RECORD OF DEFERRAL SYDNEY CENTRAL CITY PLANNING PANEL

Panel Ref – 2018SWC052 - LGA – The Hills Shire, DA1867/2018, Address – 1 Larapinta Place, Glenhaven (AS DESCRIBED IN SCHEDULE 1)

ATTACHMENT 3 – AMENDED ARCHITECTURAL AND LANDSCAPE PLANS

ATTACHMENT 4 - PEER REVIEW - PARKING AND TRAFFIC

ATTACHMENT 11 – LANDSCAPE PLAN

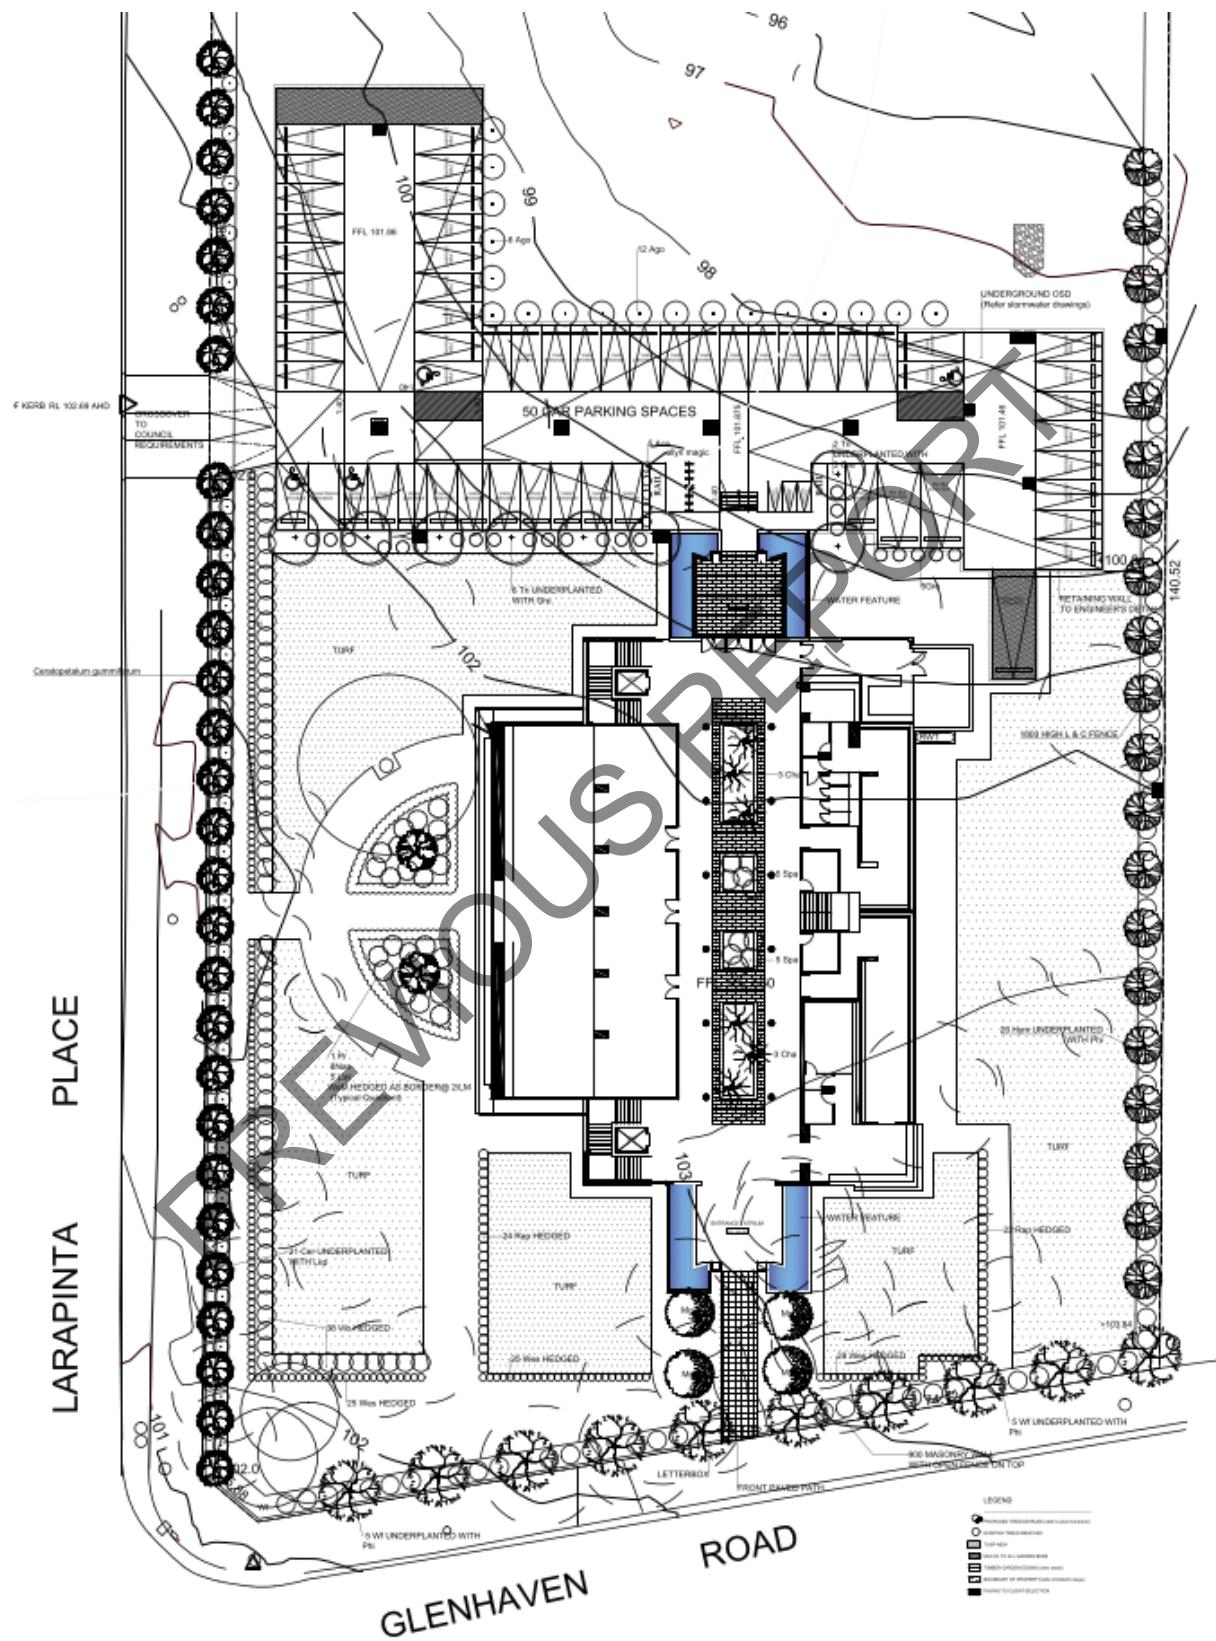
Furthermore, the landscape plan does not include any details of the species of trees or plants proposed to be provided or whether the proposed landscaping has had regard to the RFS General Terms of Approval which require the maintenance of the areas around the building to the east, south and west as an inner protection area (IPA). The requirement to maintain these areas as IPAs might result in less planting than the planting proposed on the landscape plan in which case the potential screening that the proposed landscaping might have provided will not eventuate.

No plant schedule has been provided indicating species name, size and quantities.

The development is to provide minimum 3m wide dense landscape screening to side and rear boundaries as required by the DCP. This landscape strip is to include native species from Sandstone Heath and Sandstone Gully Forest species within planting palette for trees, shrubs and groundcovers.

It is also noted that the landscape plan and architectural plans are inconsistent in relation to the car parking layout.

Site Analysis
Sedimentation Control Plan

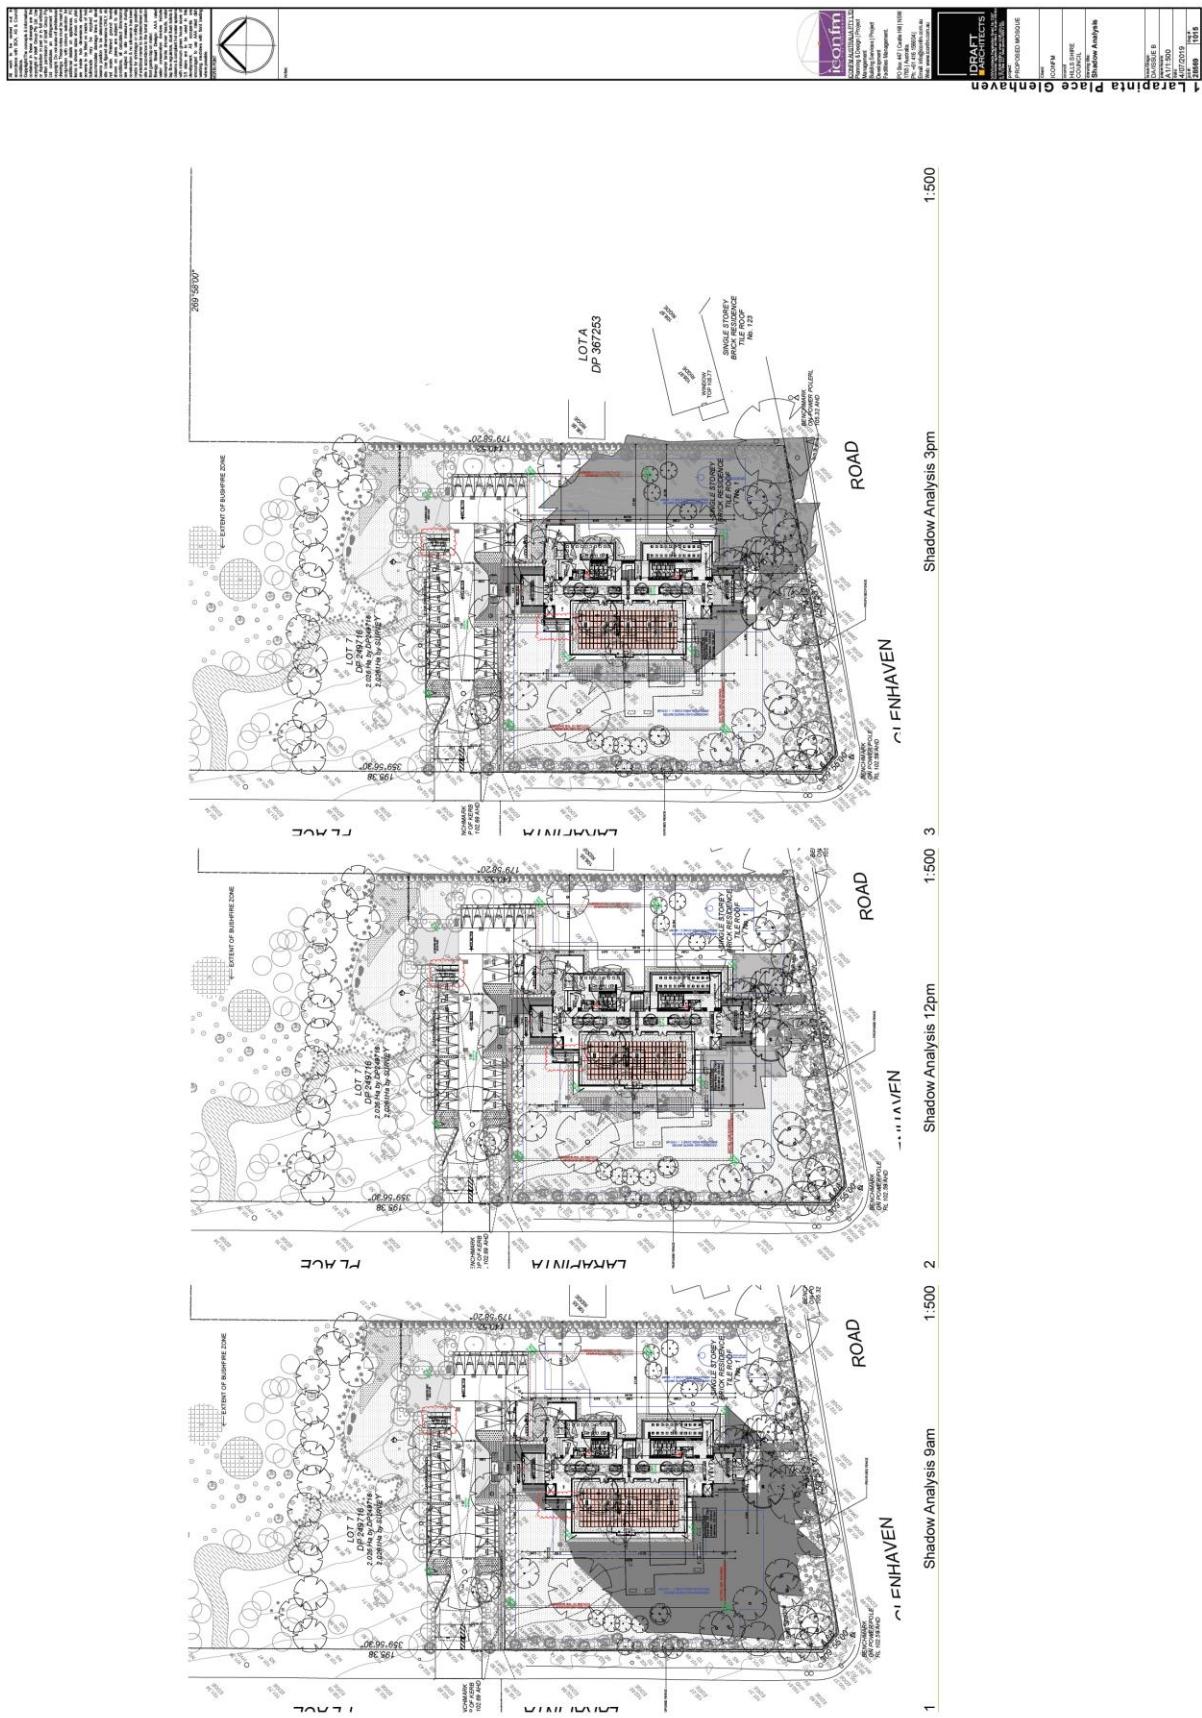
Although Drawing No. 1006 prepared by IDraft is identified as being the Sedimentation Control Plan, the plan does not include any details as to how areas downslope of the development site will be protected during the demolition and construction phases of the development.

Figure 2.4: Warrants for Right Turn Treatments

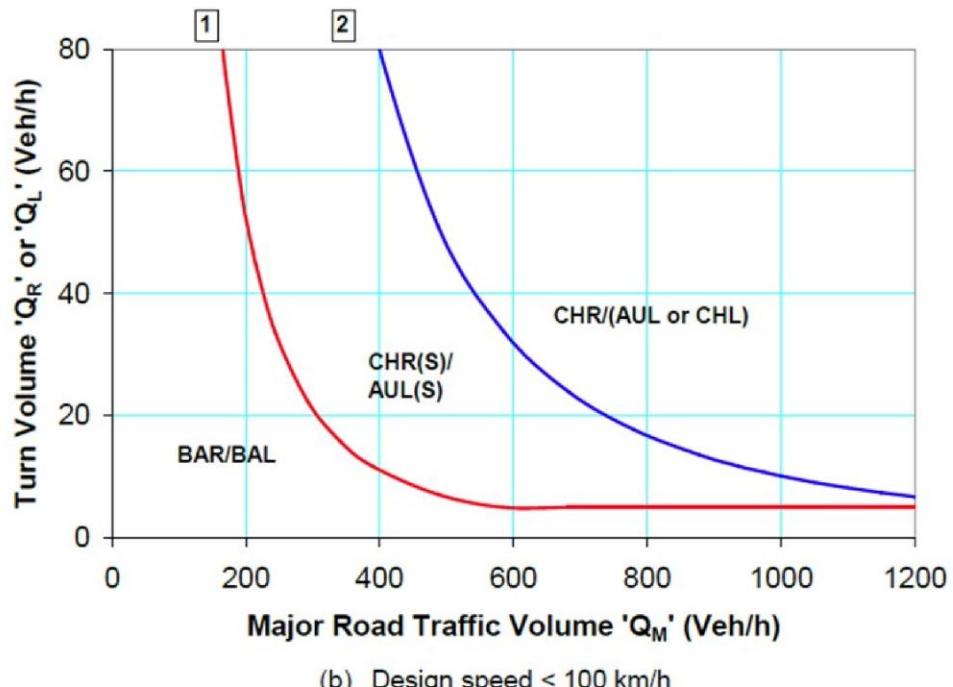
Even if only 25% came from the east, there would still be 40 vehicles per hour turning right into Larapinta Place, which meets the warrant of a high order of right turn treatment for a CHR.

Figure 2.4 shows the warrants for right turn treatments.
